# Access Compliance Report

## Public Rights-of-Way

### (Curb Ramps)

Intersection ID: 28279	Main Street: COMMUNITY_HOUSE_RD	Cross Street: PURCHASE_ST	Location: E
ADA ID: 5026F91F1056	Ramp Type: Directional1	Initial Pass/Fail: Fail	Overall Compliance: No
Severity Score: 12.5			
Codes/Mitigation Info/Possible Solution		Field Measurements/Component Compliance

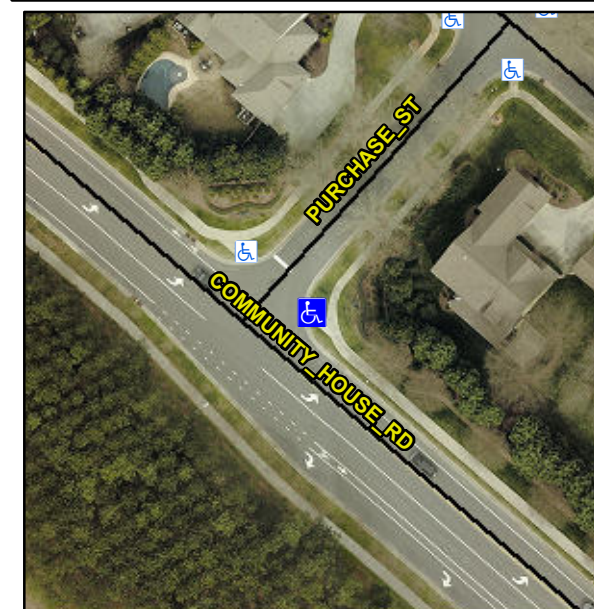
Compliance	Description	Data	Compliance	Description	Data
N/A	Ramp Length (in)	135.0	N/A	Grade Break?	N/A
Yes	Ramp Width (in)	57.0	N/A	Grade Break Slope (%)	0.0
No	Ramp Slope (%)	8.6	N/A	Grade Break XSlope (%)	0.0
Yes	Ramp XSlope (%)	0.2			
N/A	Flare Type LT	N/A	N/A	Flare Type RT	N/A
N/A	Flare Slope LT (%)	N/A	N/A	Flare Slope RT (%)	0.0
N/A	Flare Traversable LT?	N/A	N/A	Flare Traversable RT?	N/A
N/A	Landing Length (in)	0.0	N/A	DWS Provided?	N/A
N/A	Landing Width (in)	0.0	N/A	DWS Contrast?	N/A
N/A	Landing Slope (%)	0.0	N/A	DWS Length (in)	N/A
N/A	Landing X Slope (%)	0.0	N/A	DWS Full Width?	N/A
N/A	Landing Curb? (Y/N)	N/A	N/A	DWS Offset LT (in)	N/A
N/A	Shared Landing?	N/A	N/A	DWS Offset RT (in)	N/A
N/A	Gutter Ponding?	0.0	N/A	Gutter Slope (%)	N/A
N/A	Gutter Lip Ht (in)	0.0	N/A	Gutter X Slope (%)	N/A
N/A	Painted X Walk1?	No		Road Slope (%)	1.6
	X Walk 1 Direction	To NW		Road X Slope (%)	4.6
	X Walk 1 Width (in)	N/A		Clear Space?	N/A

X Walk 1 Slope (%)	1.6	N/A	Clear Space to XWalk (in)	N/A
	X Walk 1 X Slope (%)	4.6	N/A	Storm Grate/Utility Hazard?	N/A
N/A	Ramp inside XWalk1?	N/A		Storm Grate/Utility Type	
N/A	Any Obstructions?	N/A			N/A
	Obstruction Type		Yes	Surface Condition? (G/P)	Good
			N/A	Curb Slope (%)	8.2

**Remove & Replace Entire Ramp.**

**R304.2.2**
